FINAL
WESTERN TIER
TRICHLOROETHYLENE INVESTIGATION
TECHNICAL PLAN
VERSION 3.1

October 1987 Contract No. DAAK11-84-D-0017 TASK NO. 38

Appendix 38-D Ebasco's Responses to Shell Chemical Company's Review Comments of the Task 38 Technical Plan Version 2.2

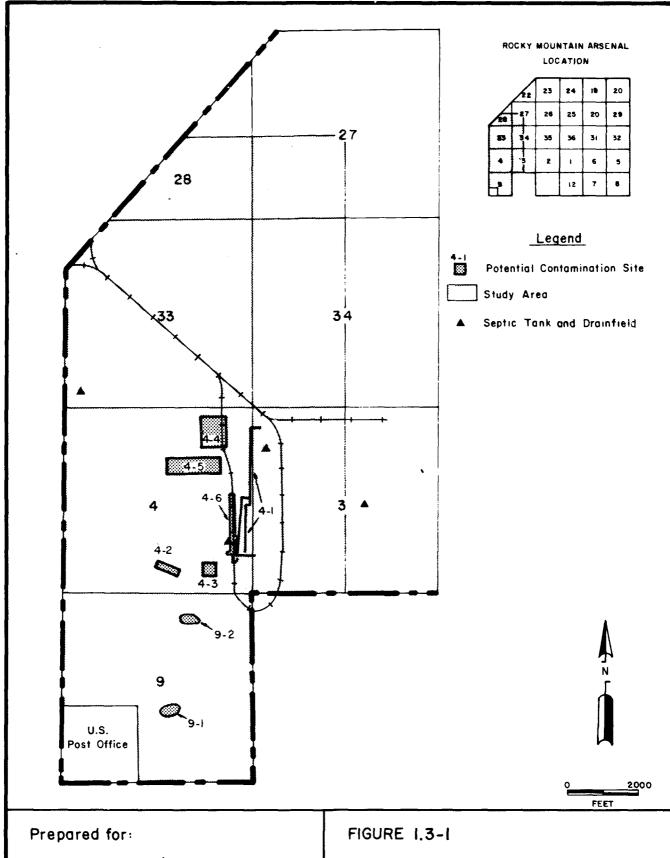
p.1-5, Section 1.3: Specific areas of interest for Task 38
include the septic tanks and drain-fields, which need further
discussion. Drain field locations are not shown on either of the
referenced Figures. The septic tank in the southwest corner of
Section 33 (Figure 1.3-1) should be investigated in a fashion

The drainfields mentioned in the technical plan are all associated with the septic tanks shown on Figure 1.3-1. Each septic tank has a drainfield. Figure 3.2-4 was referenced to illustrate the Motor Pool and Roundhouse areas which are mentioned in that same sentence. The reference has been changed to better reflect this intention. The septic tank in Section 33 was investigated in much the same manner as those in Sections 3 and 4. Whereas the septic systems in Section 3 and 4 were investigated only with the Tracer soil gas method, the septic system in Section 33 lies in an area that was blanketed with PETREX soil gas collectors. In addition, a number of Tracer soil gas samples were collected downgradient of the Section 33 septic tank.

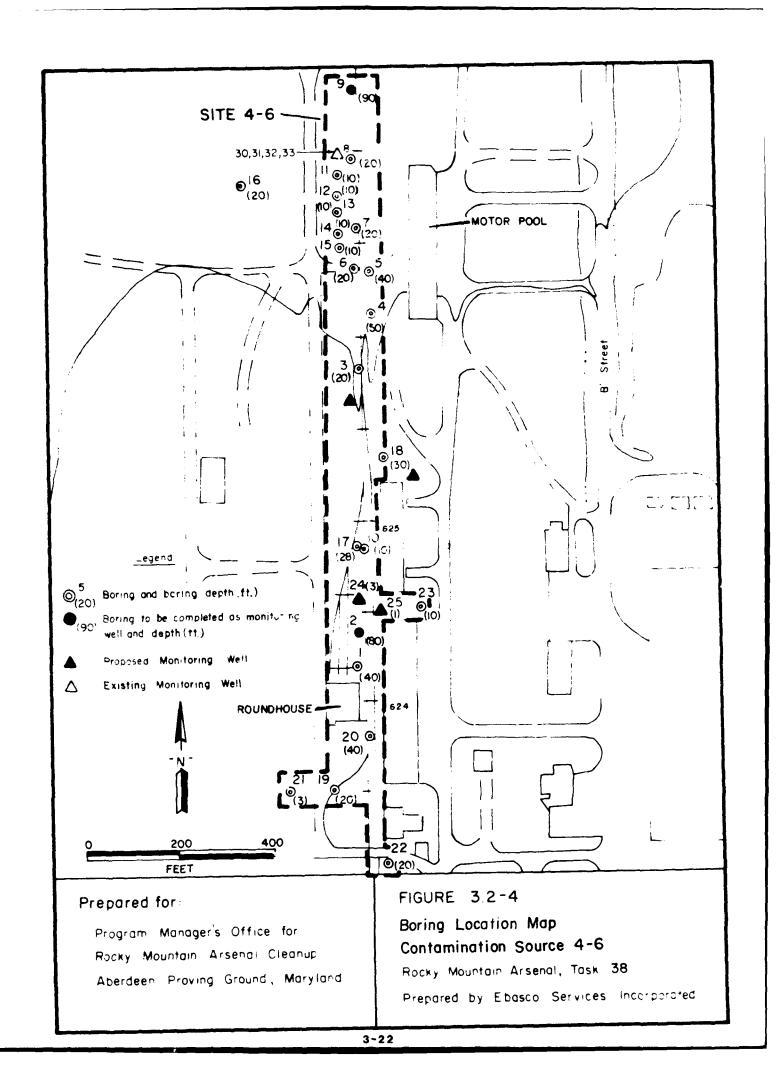
<u>Comment #6</u> p.3-20, third paragraph: Information on number and depth of borings is inconsistent with Figure 3.2-4.

Response The text has been changed and now indicates the correct number and depth of borings consistent with Figure 3.2-4.

FIGURE 3.2-5 Locations of Proposed Monitoring Wells

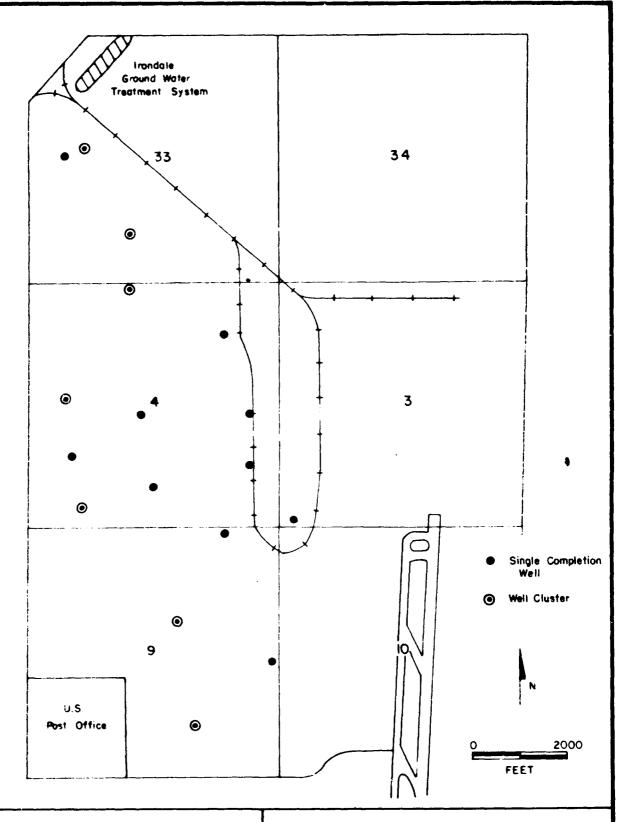
p.3-22, Section 3.2.5: The text states that the wells must be placed in the centerline of the plume, yet no data are given and Figure 3.2-5 does not show contaminant plumes nor presumed bedrock channel configuration. To determine whether the proposed well locations are appropriate or adequate more information is necessary.

Response The Task 38 technical plan proposed to conduct soil gas and geophysical programs prior to the well installation. The results of these programs were used to accurately locate the new wells. The well locations illustrated on Figure 3.2-5 were preliminary and were based on the locations of potential source areas 4-2 and 4-6; the direction of groundwater flow as determined from an ESE water table map for March 1986; and bedrock maps which have been prepared by WES and ESE. The well locations were refined based on additional soil gas, water level, and water quality data. The data from these new wells indicate that we found the plume but additional wells would be needed if the width and extent of the plume are to be refined. The Study Area Report (SAR) for the Western Tier and a Soil Gas Report will contain the results of the soil gas and geophysical programs including maps of the plumes and top of bedrock.
